RESOLUTION HOLDING HEARING REGARDING REQUEST FROM JW CONGREGATION SUPPORT, INC. (OWNER), REPRESENTED BY ARCHIE MALONE (OFFICER), FOR REVIEW AND APPROVAL OF A 2ND AMENDMENT TO THE AIRPORT CROSSROADS PUD CONCEPTUAL PLAN, ON PROPERTY LOCATED AT 7700 FLEUR DRIVE, TO ALLOW ASPHALT SHINGLES AND COMPOSITE LAP SIDING BUILDING MATERIALS WHICH ARE PROHIBITED WITHIN THE PUD

STAFF REPORT TO THE PLANNING COMMISSION

Narrative: Kingdom Hall of Jehovah's Witnesses Request for Use of Prohibited Materials per Airport Crossroads PUD

SHEET NUMBER
A-202

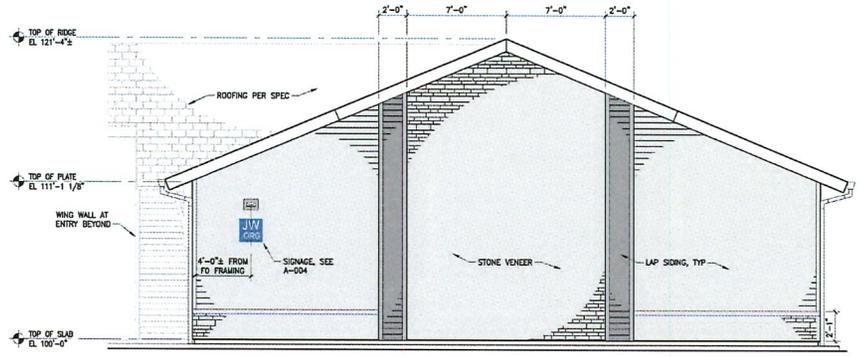
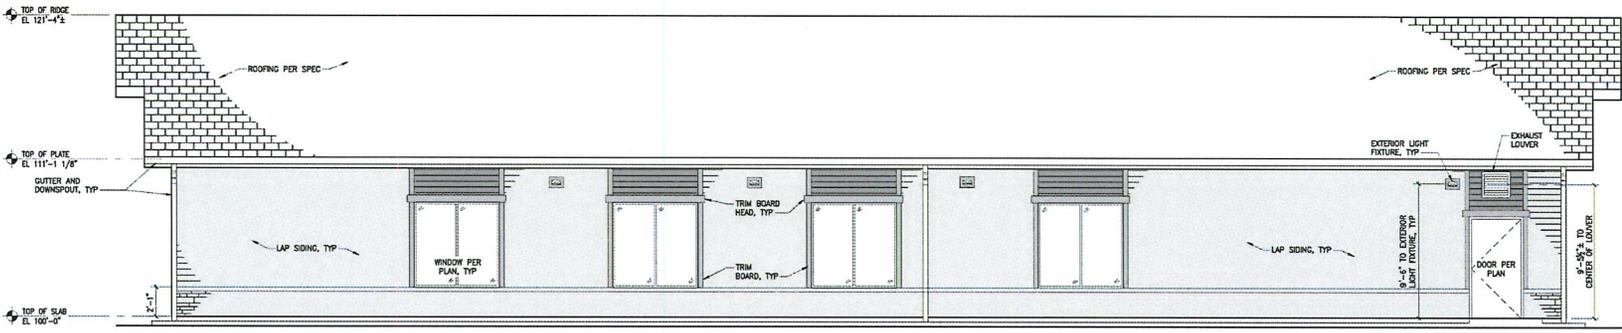
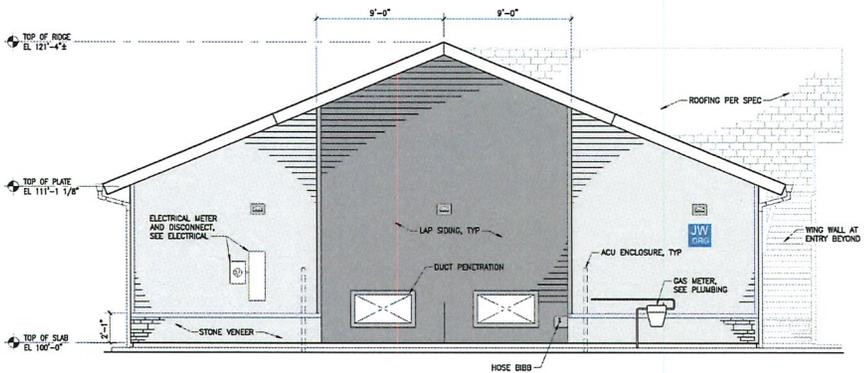
Carol Maher asked if the provided renderings show 40% lap siding.

Bert Drost stated no. The applicant will revise the drawings to comply with the staff recommendation.

- c. Composite lap siding may be used as a minor material with no more than 40% of any facade being sided with composite lap siding to the satisfaction of the Planning and Urban Design Administrator.
- d. The balance of the building shall be sided with masonry material as reviewed and approved by the Planning and Urban Design Administrator.

Proposed Jehovah Witness Kingdom Hall - 7700 Fleur Dr, Des Moines, IA 50321 – South Elevation

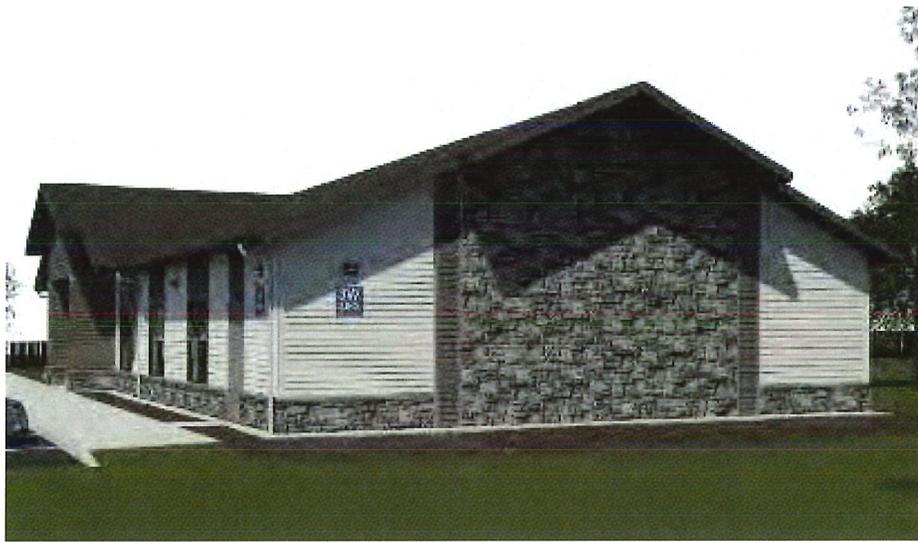
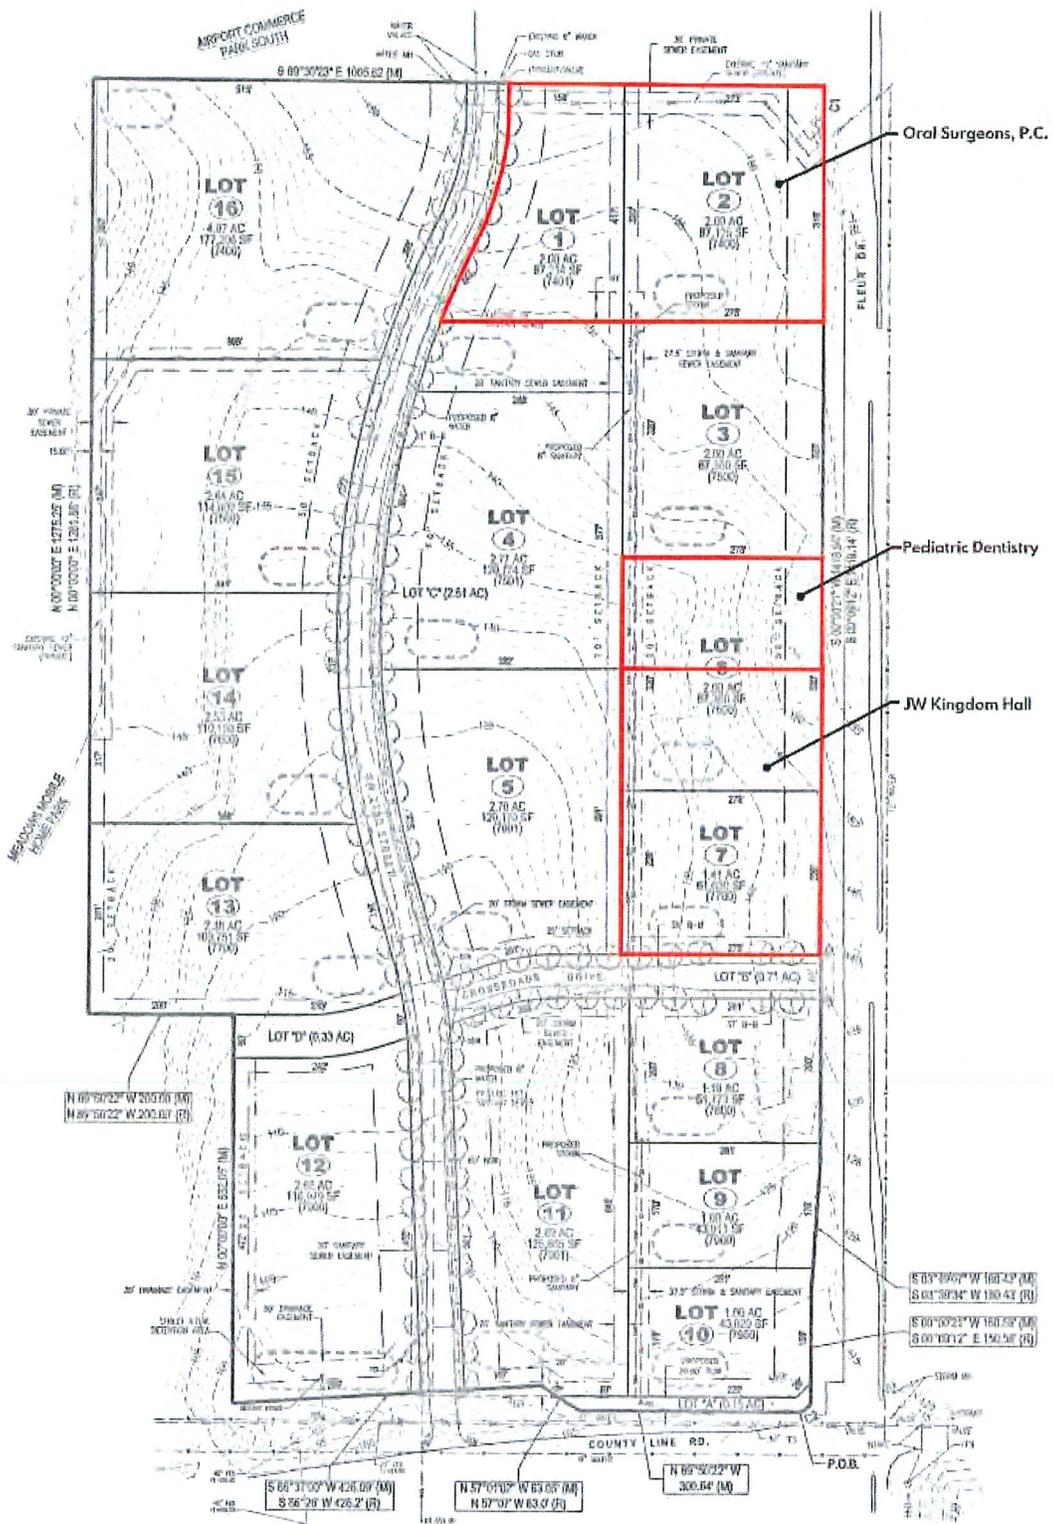
As stated in the Airport Crossroads building design standards *"All Buildings shall be designed to ensure their individual attractiveness, compatibility with each other and with the Airport Crossroads environment. Buildings shall be constructed of permanent materials such as brick, architectural precast panels, tilt-up concrete, stone EIFS, metal, and glass."* However, it is noted that the two adjoining properties located at 7400 Fleur Dr and 7600 Fleur Dr have implemented the use of asphalt shingles as well as composite siding.

Prime Architects propose that to ensure that individual attractiveness and compatibility with each other and with the Airport Crossroads environment is maintained, implement the use of asphalt shingles, as well as composite siding.

Another common design element seen with properties 7400 Fleur Dr and 7600 Fleur Dr is the use of a stone wainscot. Likewise, Prime Architects proposes the use of a stone wainscot surrounding the building periphery. Additionally, the proposed wainscot visually attenuates the lap siding as noted in the previous drawings.
